# CITY OF ALBUQUERQUE

### RE: 2440 Louisiana NE Grading and Drainage Plan Engineer's Stamp Date: 5/14/19 Hydrology File: H19D084

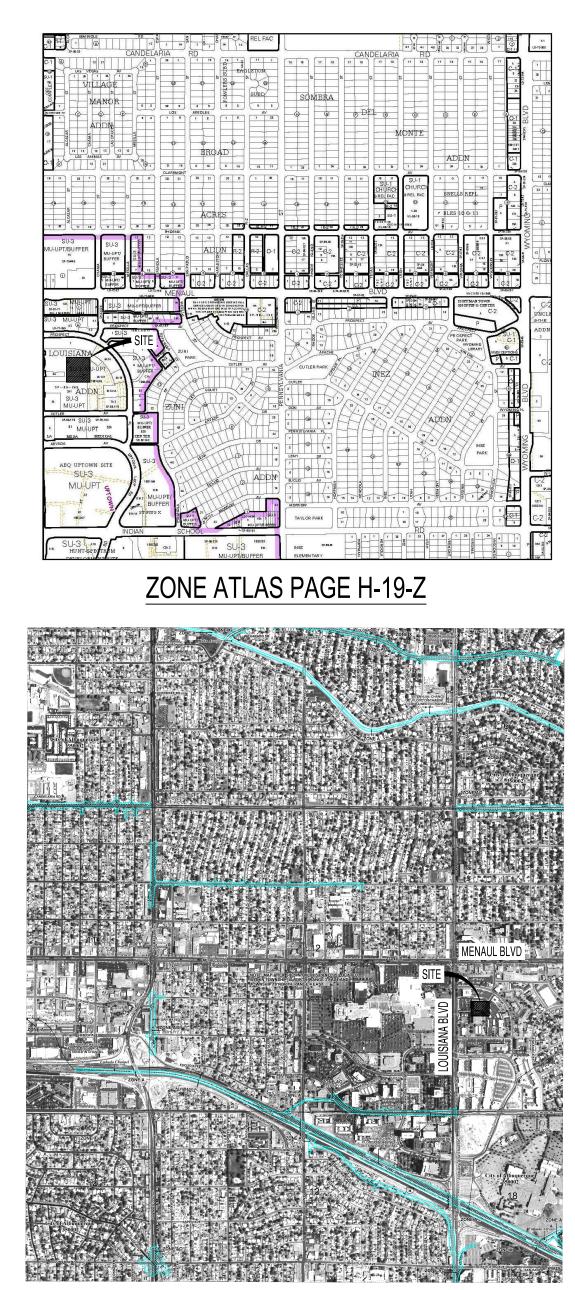
PO Box 1293		nnot be approved for Grading or Paving Permit until the following corrections are made:
Albuquerque	1.	Onsite detention is required. The capacity of the storm drain in Louisiana has been exceeded; therefore discharge is limited to 0.1cfs/ac. No increased runoff to overcapacity systems can be authorized per § 14-5-2-12 (G) of the Albuquerque Code of Ordinances.
NM 87103	2.	Provide two detailed and scaled exhibits of the land treatments; one for existing and one for proposed. Delineate between areas of impervious and pervious cover on both and provide the area take-offs.
www.cabq.gov	3.	Storm water quality calculations are missing. This site qualifies as redevelopment and is only required to retain runoff from the 80th percentile storm (Vol. = $0.26$ ''*Imp.Area).

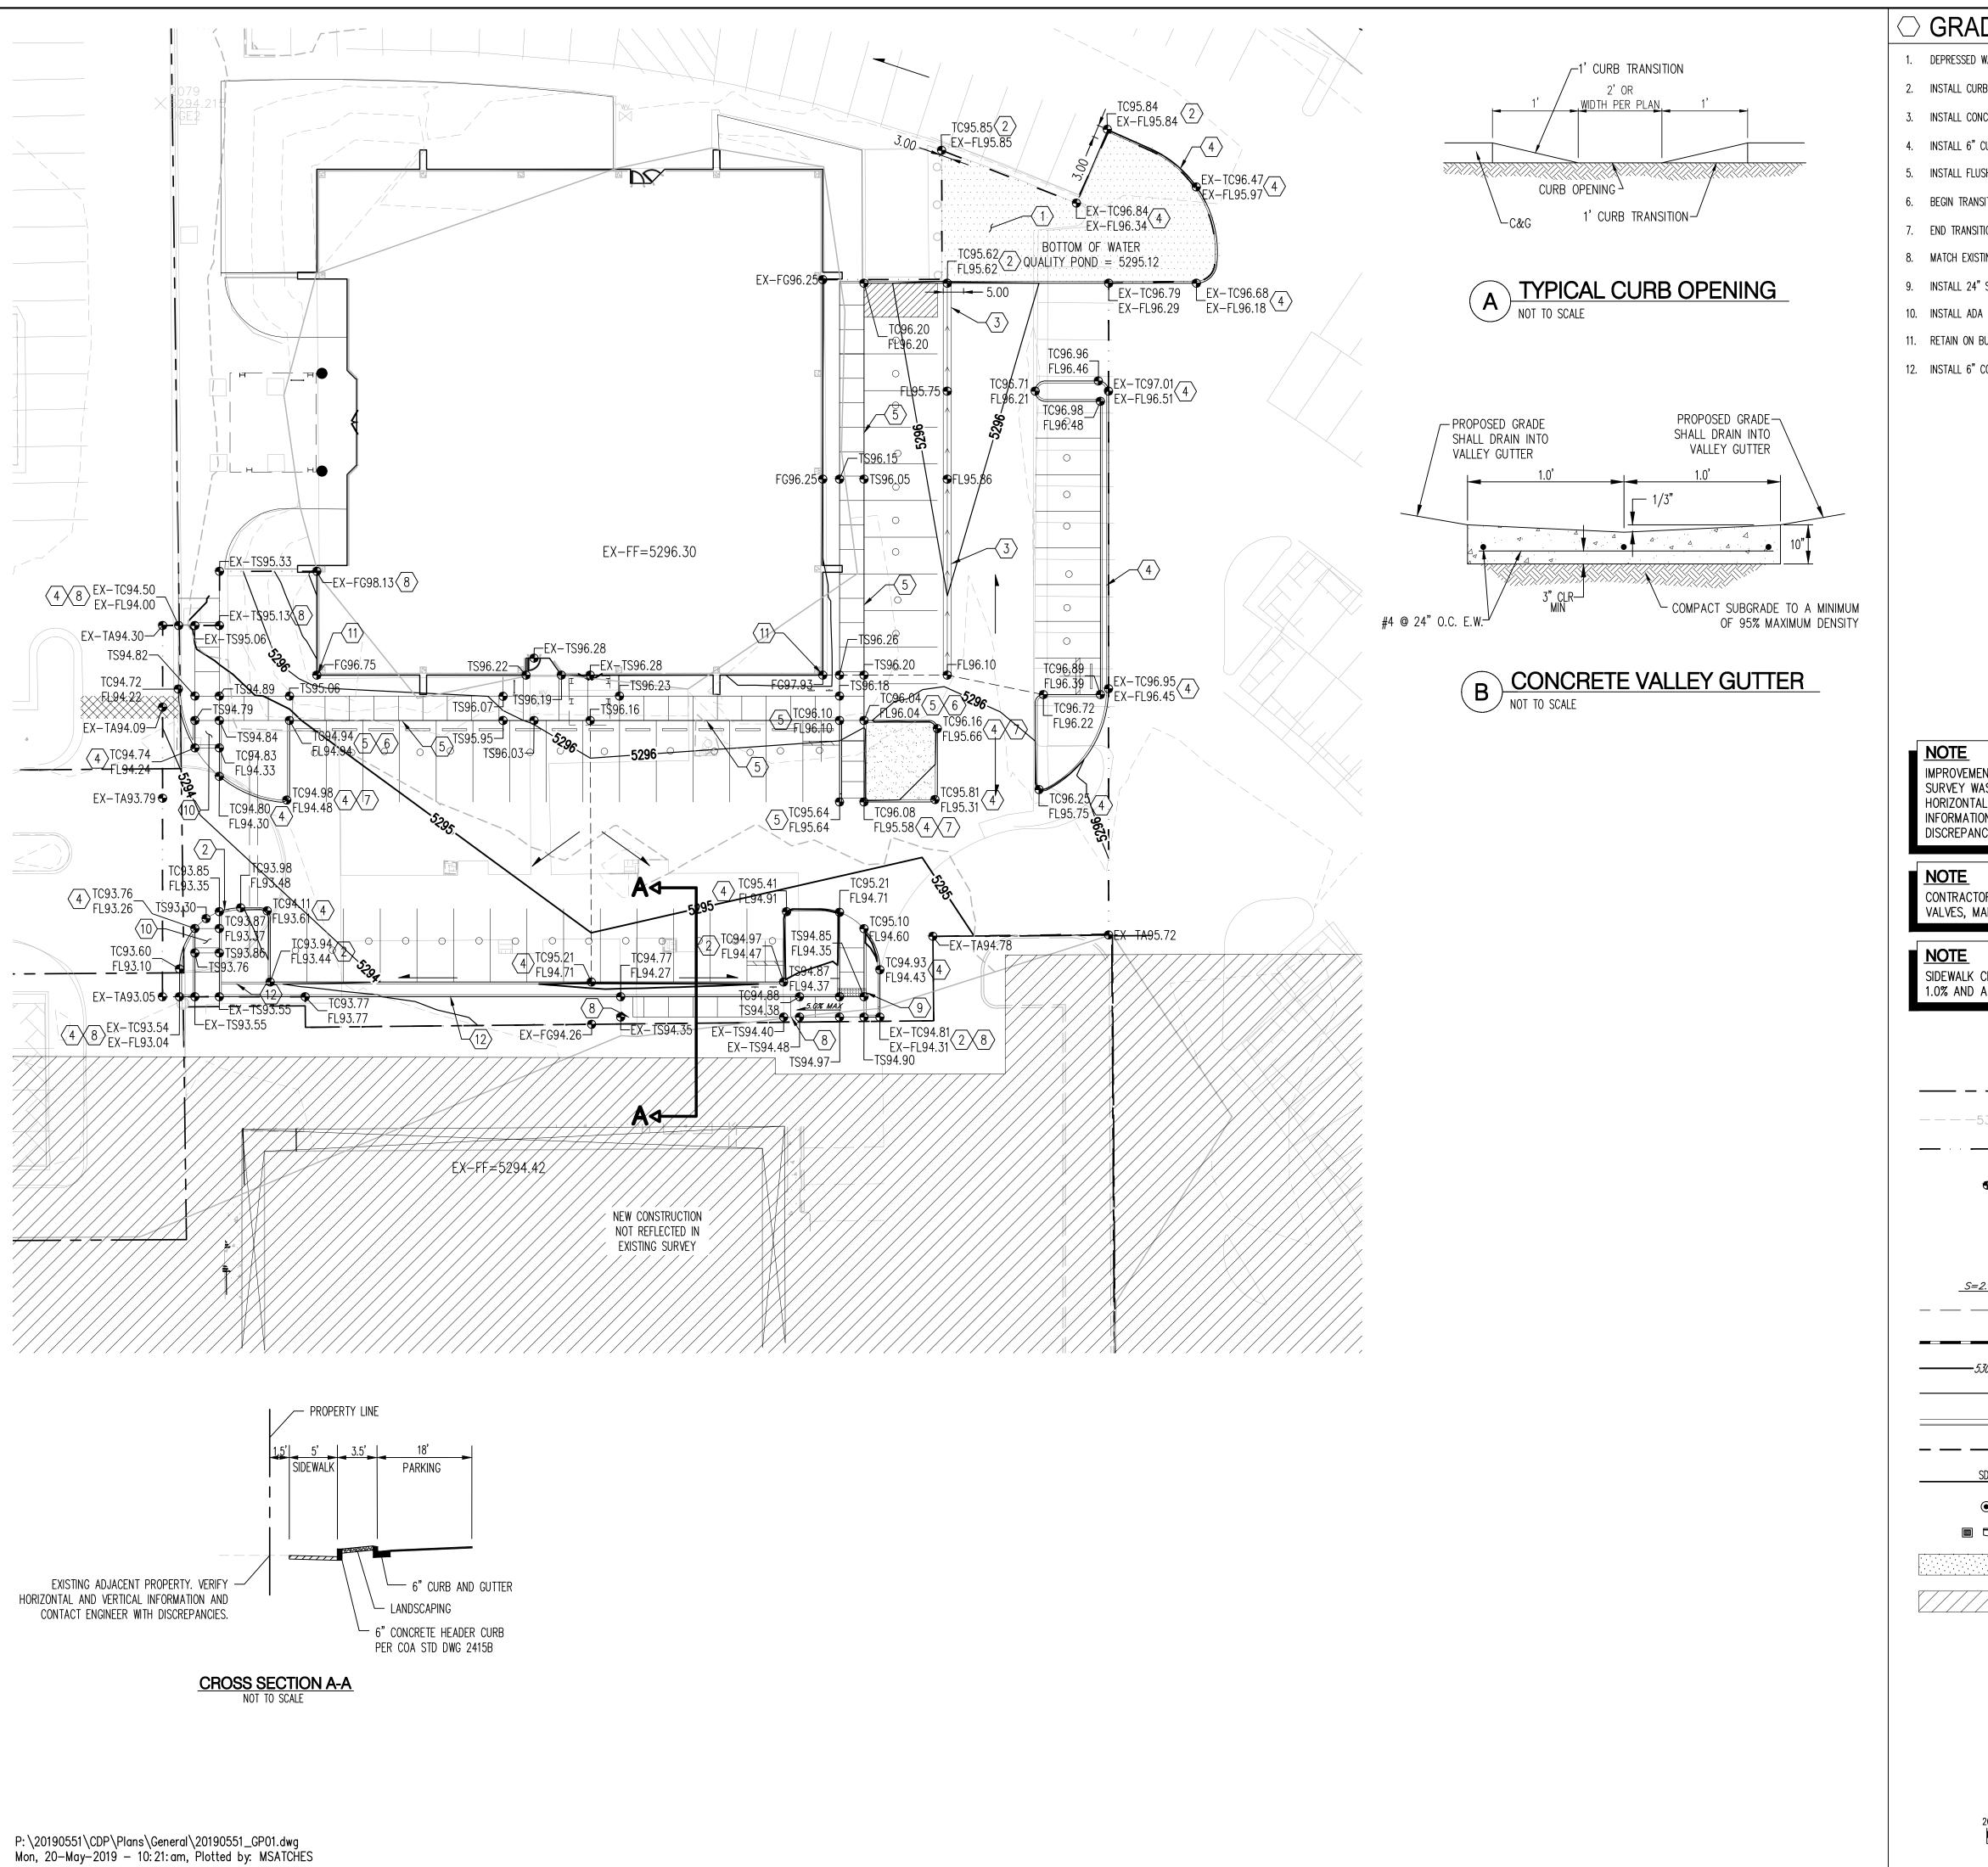
5.	Show the contours and grades for the adjacent underground parking structure entrance. Special care must be taken to ensure no additional runoff is directed toward it. New survey data is required.

6.	Provide written and signed permission from the adjoining property to the south for any new discharge to their property.

7. Include project benchmark and datum.
